MIL-S-19500/116J
AMENDMENT 1
20 October 1992

SEMICONDUCTOR DEVICE, DIODE, SILICON, SWITCHING
TYPES 1N914, 1N4148-1, AND 1N4531
JAN, JANTX, AND JANTXV

FIGURE 2. Physical dimensions 1N914UR, 1N4148UR-1, AND 1N4531UR."

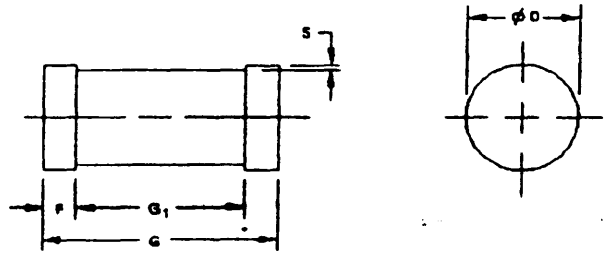
After figure 1, add new figure 2:

Symbol	Dimensions			
	Inches		Millimeters	
	Min	Max	Min	Max
ϕD	.063	.067	1.60	1.70
F	.016	.022	0.41	0.55
G	.130	.146	3.30	3.70
G_1	.100 ref		2.54 ref	
S	.001 min		0.03 min
